Access Compliance Report

Public Rights-of-Way

(Pedestrian Signals)

Intersection ID: N/A	Main Street:	Cross Street: N/A	Location: N/A
ADA ID: 072A30DF2F47	Signal Type: Two Push Buttons-APS	Overall Compliance: No	Severity Score: BTN 1:N/A BTN 2: N/A No BTN: N/A
Codes/Mitigation Info/Possible Solution		Field Measurements/Component Compliance

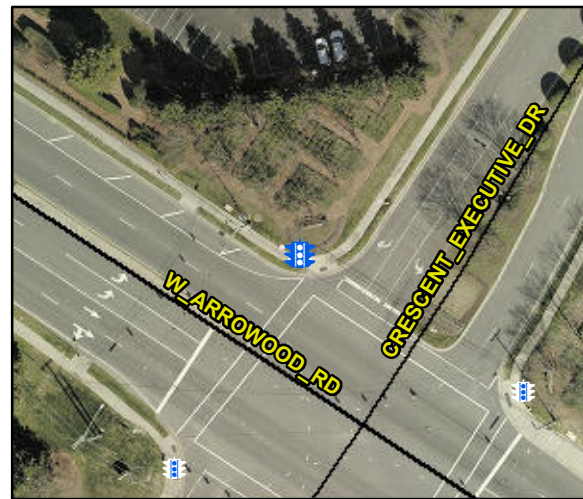
Surveyor Notes: TX HEIGHT 3/8

PROW/ADA: R410.6, R209.1, TMUTCD 4e.08, R404.2, R404.3, R406.2, R404.7.3,

Compliance	Description	Data	Compliance	Description	Data
	Button Count	Button2	N/A	Distant to Additional Button (in)	N/A
	Additional Button Present?	N/A		Additional Button ID	N/A
N/A	Signal Buttons Required?	N/A	N/A	Additional Ped Posts Required	N/A
	How Many Ped Street Xings?	2		Located In An Island/Median?	No
N/A	B 1 Sign Present?	Yes	N/A	B 2 Sign Present?	Yes
Yes	B 1 Sign Purpose?	Yes	Yes	B 2 Sign Purpose?	Yes
No	B 1 Sign Lettering & Contrast?	No	No	B 2 Sign Lettering & Contrast?	No
No	B 1 Parallel To XWalk?	No	Yes	B 2 Parallel To XWalk?	Yes
Yes	B 1 PAR to Button?	Yes	Yes	B 2 PAR to Button?	Yes
Yes	B 1 PAR to XWalk?	Yes	Yes	B 2 PAR to XWalk?	Yes
Yes	B 1 Clear Floor Space?	Yes	Yes	B 2 Clear Floor Space?	Yes
N/A	B 1 FWD Approach?	Yes	N/A	B 2 FWD Approach?	Yes
N/A	B 1 FWD Approach Constrained?	No	N/A	B 2 FWD Approach Constrained?	No
No	B 1 FWD Approach Reach (in)	16.0	No	B 2 FWD Approach Reach (in)	12.0

N/A	B 1 FWD Approach Width (in)	N/A	N/A	B 2 FWD Approach Width (in)	N/A
N/A	B 1 FWD Approach Obstruction?	Yes	N/A	B 2 FWD Approach Obstruction?	Yes
N/A	B 1 FWD Approach Obstruction Dist (in)	8.0	N/A	B 2 FWD Approach ObstructionDist (in)	8.0
N/A	B 1 PARA Approach?	Yes	N/A	B 2 PARA Approach?	Yes
N/A	B 1 PARA Approach Constrained?	No	N/A	B 2 PARA Approach Constrained?	No
No	B 1 PARA Approach Reach (in)	14.0	No	B 2 PARA Approach Reach (in)	12.0
N/A	B 1 PARA Approach Width (in)	N/A	N/A	B 2 PARA Approach Width (in)	N/A
N/A	B 1 PARA Approach Obstruction?	Yes	N/A	B 2 PARA Approach Obstruction?	Yes
N/A	B 1 PARA Approach Obstruction Dist (in)	8.5	N/A	B 2 PARA Approach ObstructionDist (in)	8.0
No	B 1 Clear Floor Space Slope (%)	5.6	No	B 2 Clear Floor Space Slope (%)	6.3
No	B 1 Clear Floor Space XSlope (%)	3.0	No	B 2 Clear Floor Space XSlope (%)	2.5
N/A	B 1 PAR Slope (%)	3.6	N/A	B 2 PAR Slope (%)	5.0
Yes	B 1 Height (in)	39.0	Yes	B 2 Height (in)	39.0

Yes	B 1 Clear Xing Direction?	ClearlyMarked	Yes	B 2 Clear Xing Direction?	ClearlyMarked
	B 1 Crossing Direction	To SW		B 2 Crossing Direction	To SE
No	B 1 DistanceTo XWalk (in)	108.0	Yes	B 2 DistanceTo XWalk (in)	60.0
No	B 1 DistanceTo Curb (in)	120.0	No	B 2 DistanceTo Curb (in)	120.0
Yes	B 1 Diameter (in)	2.0	Yes	B 2 Diameter (in)	2.0

Possible Solutions: Replace Signal Push Button With APS Button on New Post. Remove & Replace Sign.
